Public Comments Regarding GMA-12 DFC/MAG Preliminary Scenarios

I also reviewed the 2014 Annual Report. A Report given by the District's hydrologist in May 2014 is quoted below. My comments are interjected in blue/underlined text.

Figure 1

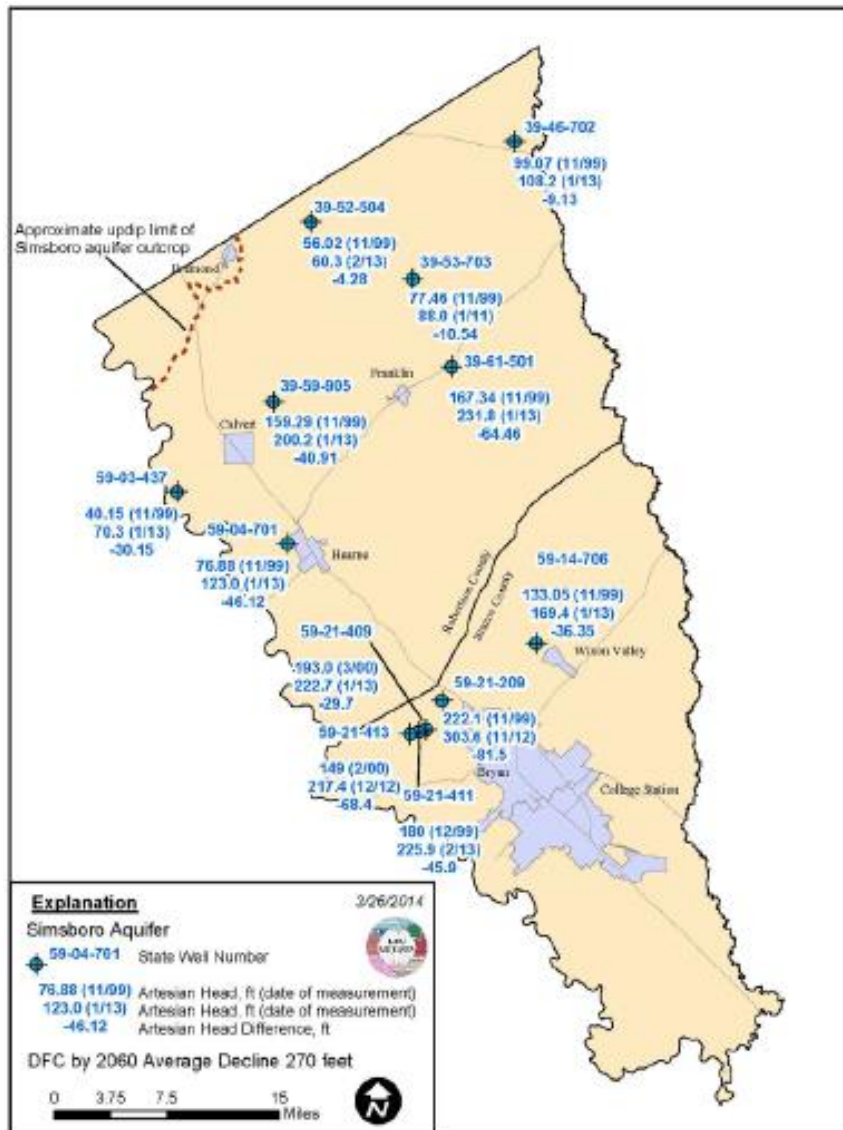
In Robertson County the amount of artesian head decline is influenced by the increase in pumping for agriculture in the area west of Hearne. Even with that pumping, the head decline in Well 59-03-437 is a good indicator of aquifer artesian head change as that well is pumped on a limited basis. Well 59-03-437 is actually west of Calvert and is shown in Figure 1 as having an average drawdown of 30.15 feet. Well 59-04-001 is west of Hearne. At this time do not have a good explanation for the amount of artesian head decline in Well 39-61-501. Well 39-61-501 data shows a recorded static level of -231 ft. every month from 3/2013 to 8/2014. This is obviously abnormal but was still included in the "average."

The DFC is an average of 270 feet of artesian head decline occurring by 2060. If we take the average for the 12 wells measured, the artesian head decline is about 39 feet for the period 2000 through about the beginning of 2013. First, why not take all 59 Simsboro monitored wells? Second, why select 1/2013 for the end date when several more months of collected data was available? Third, why take an average of these wells, when plotting trend lines would have been a much better indicator of our actual decline?

Of the twelve selected wells, please consider the following seven in Robertson County as identified above (also Attachment A).

1. Well 39-52-504 is located in northern Robertson County a good distance from the primary producer of Simsboro groundwater and is over the Simsboro outcrop.

2. Well 39-46-702 is located in the NE corner of Robertson County a good distance from the primary producer of Simsboro groundwater, near the Navasota River and Lake Limestone and over the Carrizo-Wilcox outcrop zone.

3. Well 39-53-703 is a domestic/livestock well with no reading dated 1/11 on water level report and the last reading was taken in 7/2011. There have been no recorded readings since 7/2011. This well is over the Carrizo-Wilcox outcrop zone.

4. Well 39-61-501 is the well mentioned above with the identical water levels for 14 consecutive months.
5. Well 59-03-437 is very close to the Brazos River and “pumped on a limited basis.”

6. Well 39-59-905 is a domestic/livestock well NE of Calvert with no reading dated 1/11 on the water level report and is over the Carrizo-Wilcox outcrop zone.

Figure 2

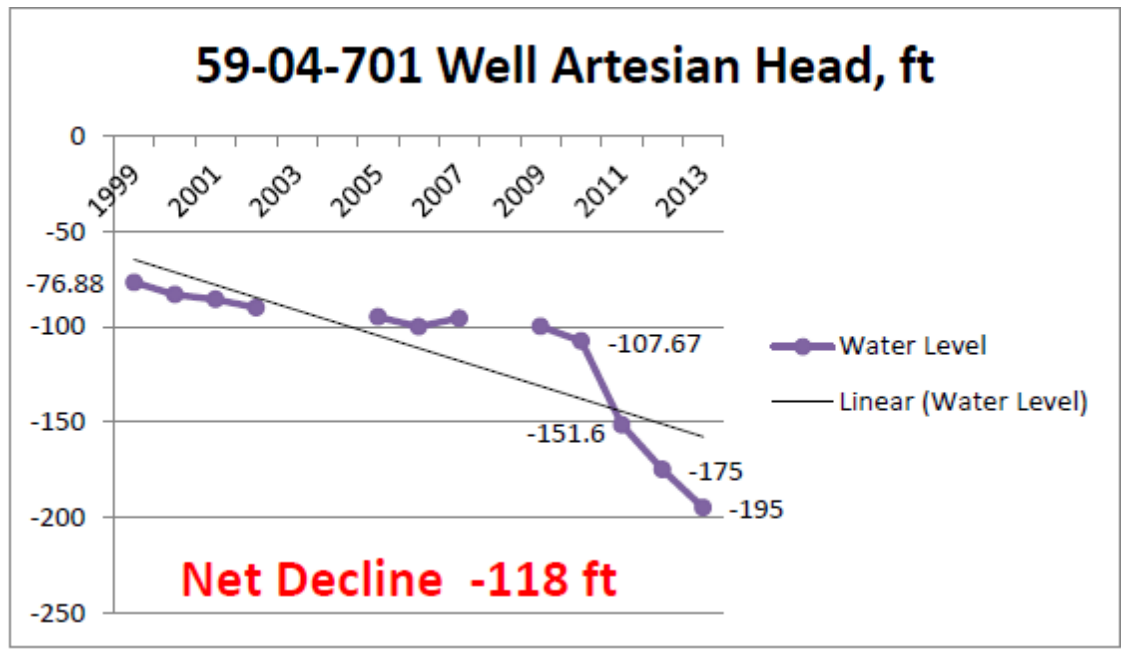
7. Well 59-04-701 is a municipal well located within 5 miles of several large producing agricultural wells. This well is not a primary well used by the City of Hearne residents. Please note the dramatic decline of water levels beginning in 2010 in Figure 2. This coincides with the arbitrated settlement of contested permits and the beginning of an annual 20,000 ac.ft. withdrawal of the Simsboro groundwater for agricultural irrigation west of Hearne.

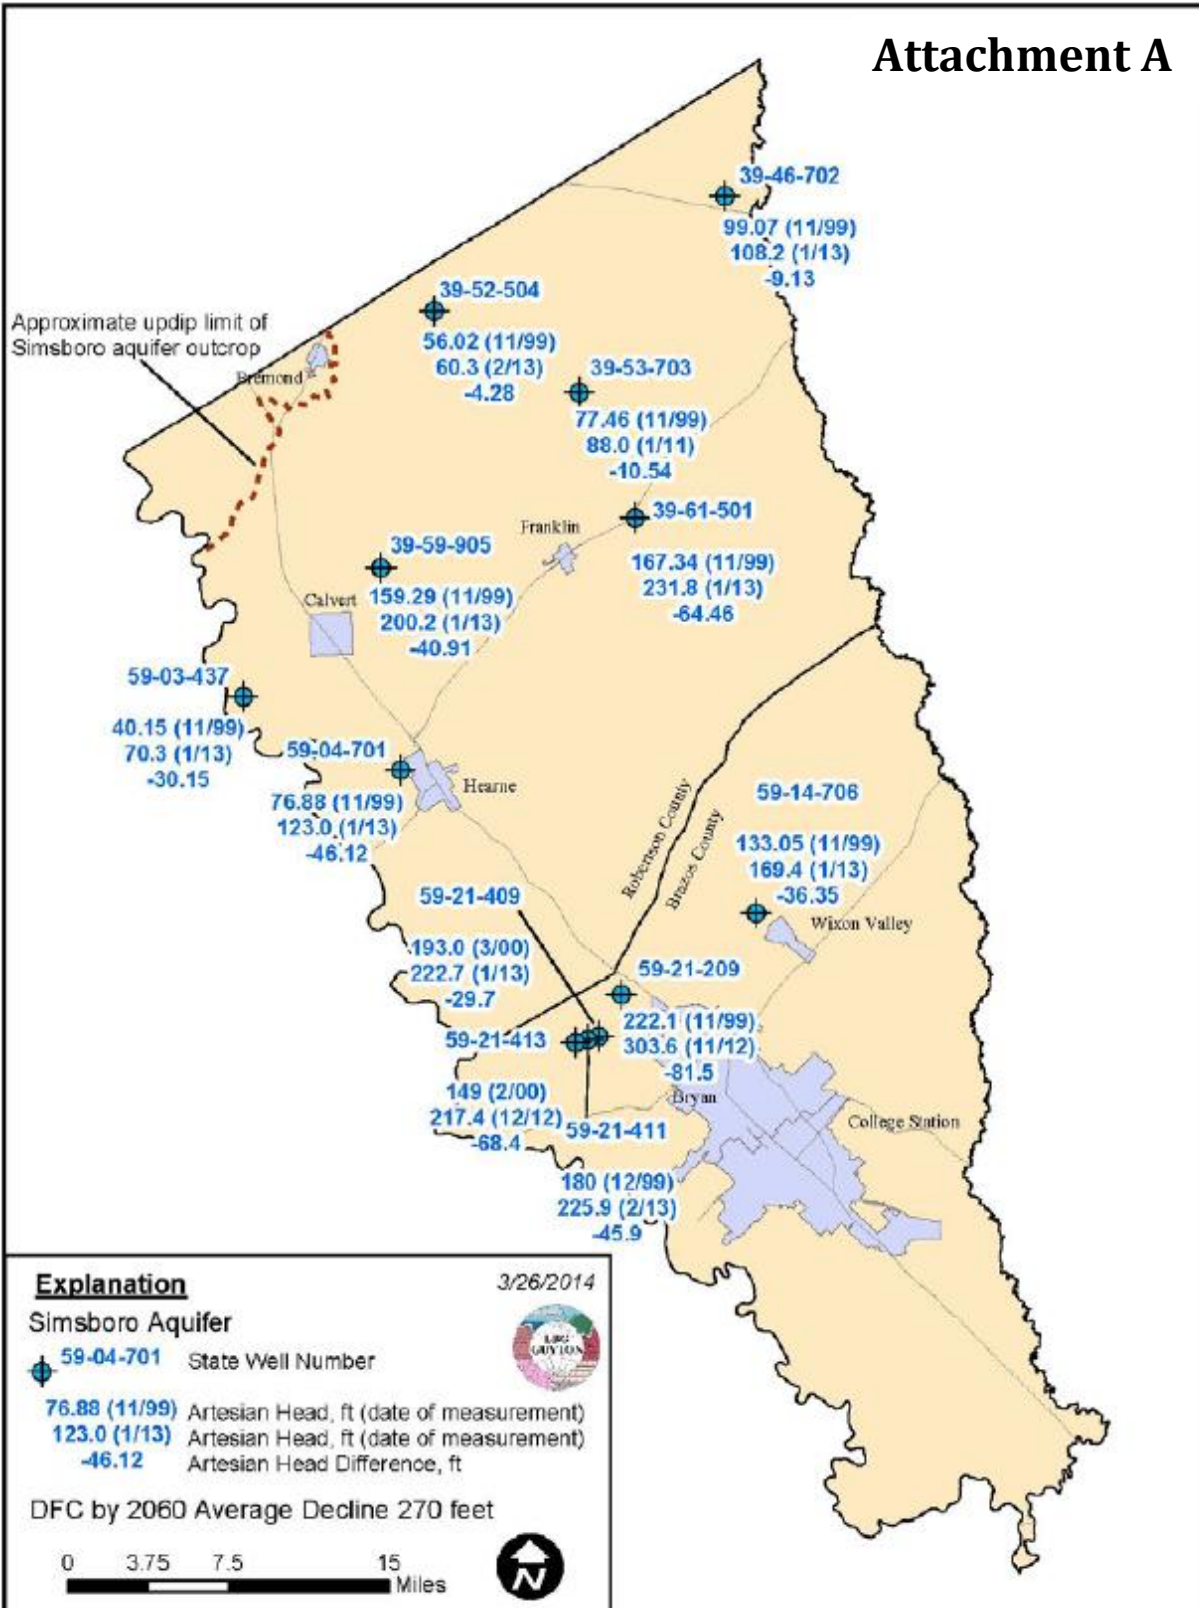
My last comment regarding this letter is somewhat explained by reviewing Attachment B. It is obvious that selective data may express true facts to derive a completely erroneous or misleading “prediction.” The datasets are available to evaluate our wells by plotting water levels by year and extending the slope of the line for predictive results (Attachment C) rather than accepting a poorly grouped average.
